SCALE	2/1	UNIT	m/m	SIGNATURE	DATE	KINPO ELECTRONICS, INC.		
TOL.	1PLC	2PLC	ANGL	DESIGN	JUNE '07	TITLE		
F	0.1	0.05		DRAW:	27	BF12A LCD (10 DIGITS)		
MATERIAL:				CHECK:		G:\BF12A\10		
FIRST APPLICATION				SIZE	A3	DRAWING NO. L07002		
NEXT ASSY MDL NO.				SHEET	1 OF 1	REV. 0

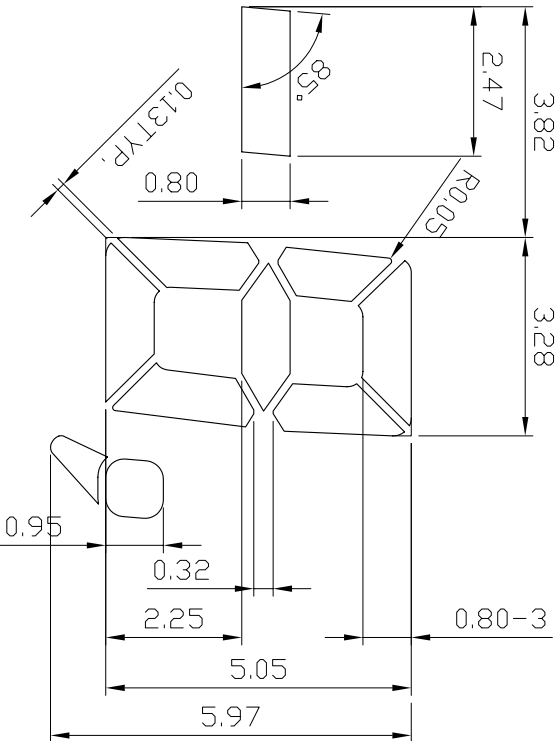
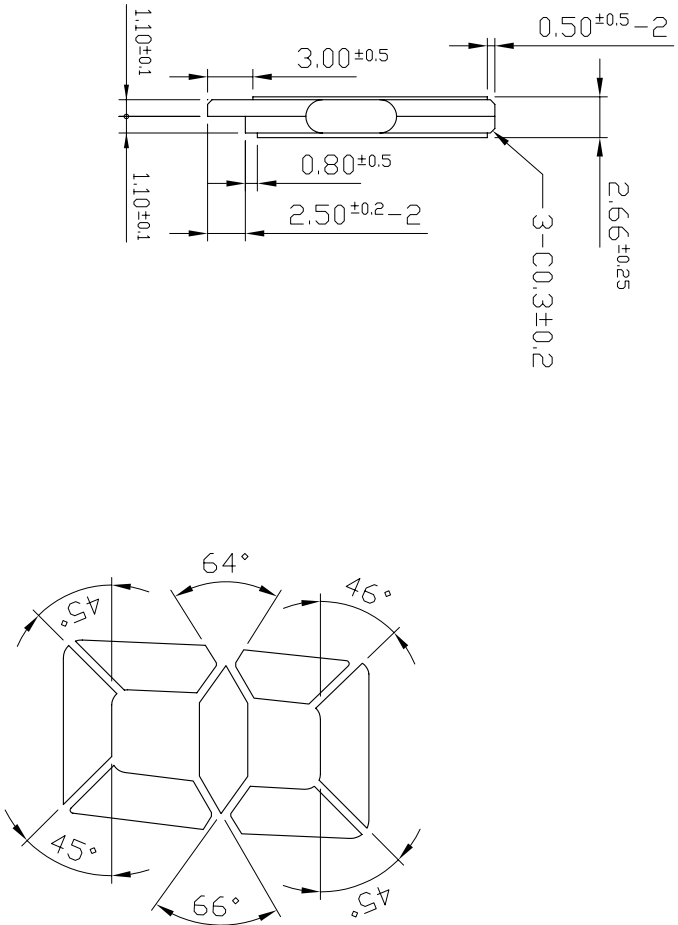
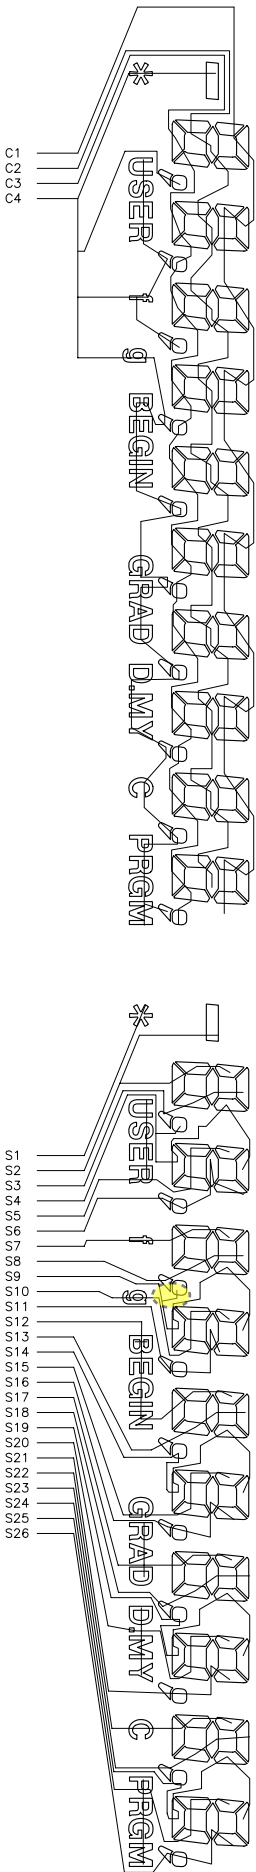
In the previous LCD drawing, this dot was not connected to wire. We have connected this dot to S9 line. The modified drawing is as below. If there is no problem with this modified drawing, pls kindly modify SW to comply with current change.
